LAND USE REVIEW RESULTS AND COMMENTS

DATE OF COMMENTS: **February 25, 2020**
CASE MANAGER: **Sloane Walbert**
PROJECT NAME: **WATERVIEW**
LOCATION: **5801 ARAPAHOE RD**
REVIEW TYPE: **Site Review**
REVIEW NUMBER: **LUR2019-00021**
APPLICANT: **BILL HOLICKY, COBURN PARTNERS**
DESCRIPTION: **Request to develop a 14.88-acre vacant property with 317 residential units and roughly 16,000 square feet of ground floor commercial space for office, retail, and restaurant uses. The proposal includes constructing 10 buildings surrounding a loop drive, with one access from Arapahoe Avenue. Four hundred twenty two parking spaces are proposed, 294 of which are located in a central parking structure. The development would include 25% permanently affordable housing. Proposed residential units would consist of 133 efficiency units (less than 475 square feet), 144 one-bedroom, 18 two-bedroom, and 22 three-bedroom units. Buildings would be 3- and 4-stories in height, with the exception of the community building that would be 2-stories. Refer to LUR2019-00022 for companion use review.**

SHEET NO.
LP-101
Planting Plan

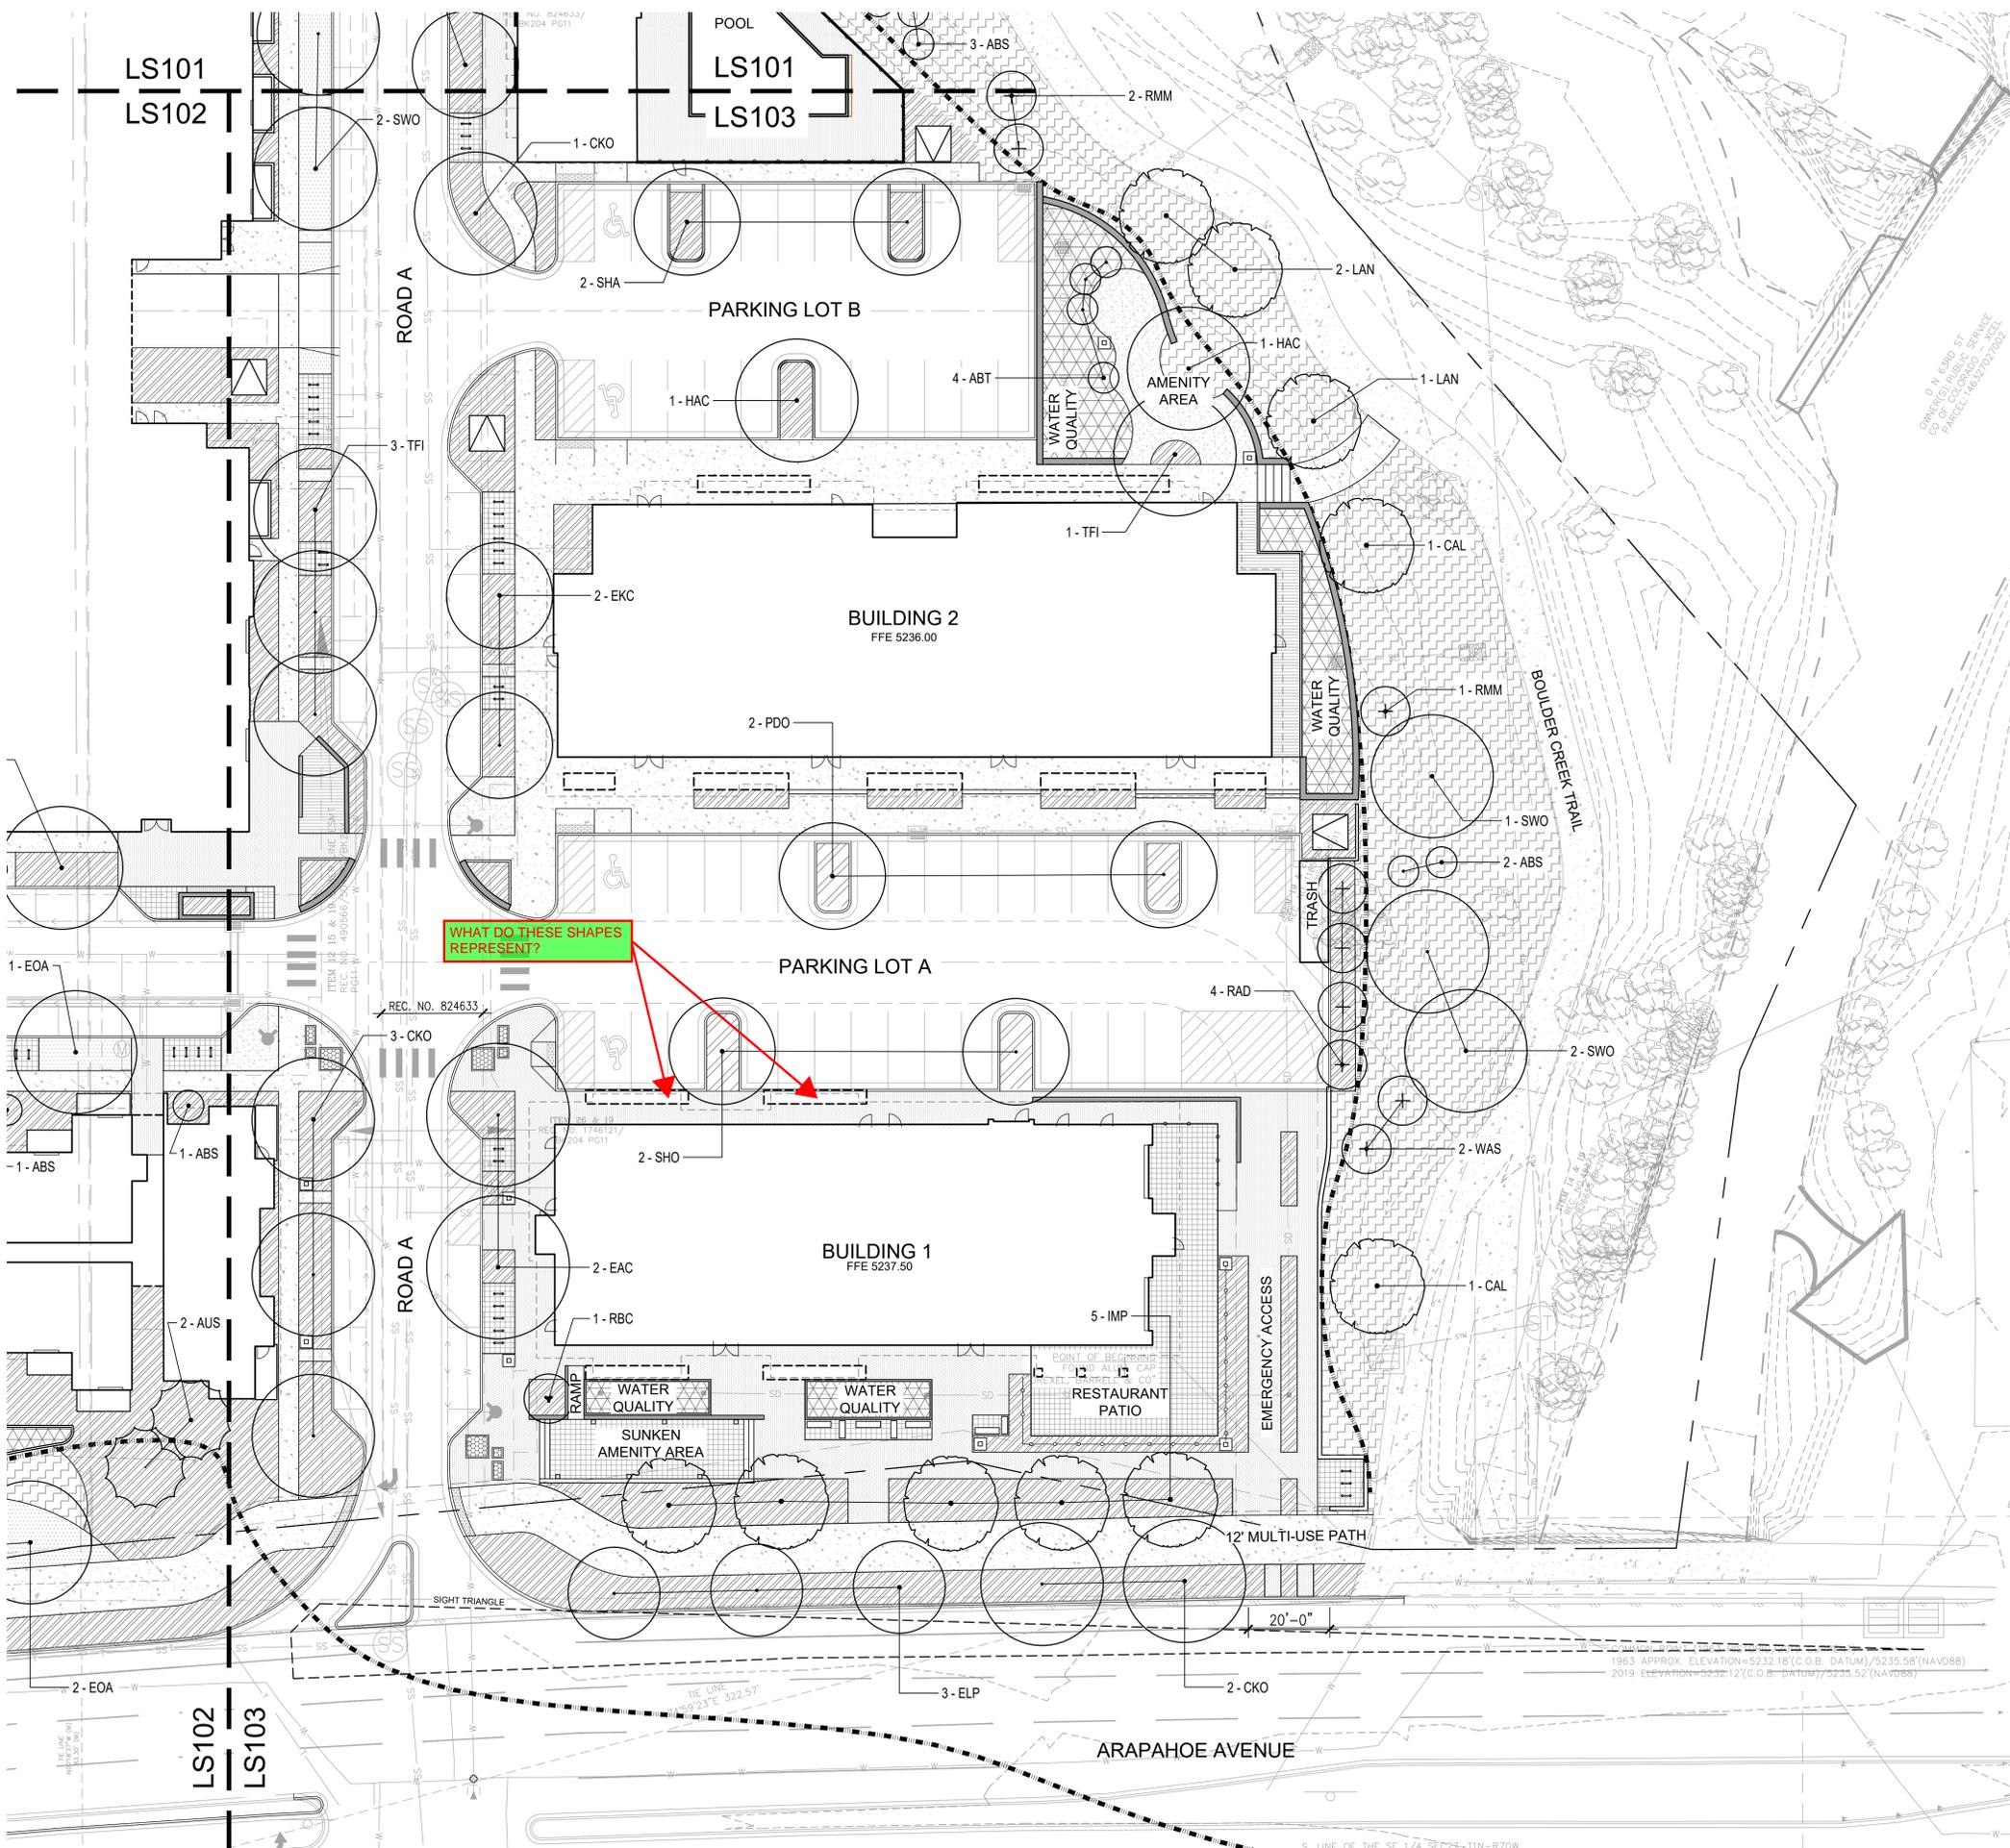
PRIOR COMMENTS REQUIRE MOVEMENT OF WATER SERVICE TO BLDG 7 TO ALLOW FOR TREE PLANTINGS. REVISE PLANTING PLAN TO ACCOMMODATE.

ALIGNMENT OF STORM LINE IS IN DIRECT CONFLICT WITH PROPOSED TREE PLANTINGS. REVISE PLANTING PLAN TO ACCOMMODATE.
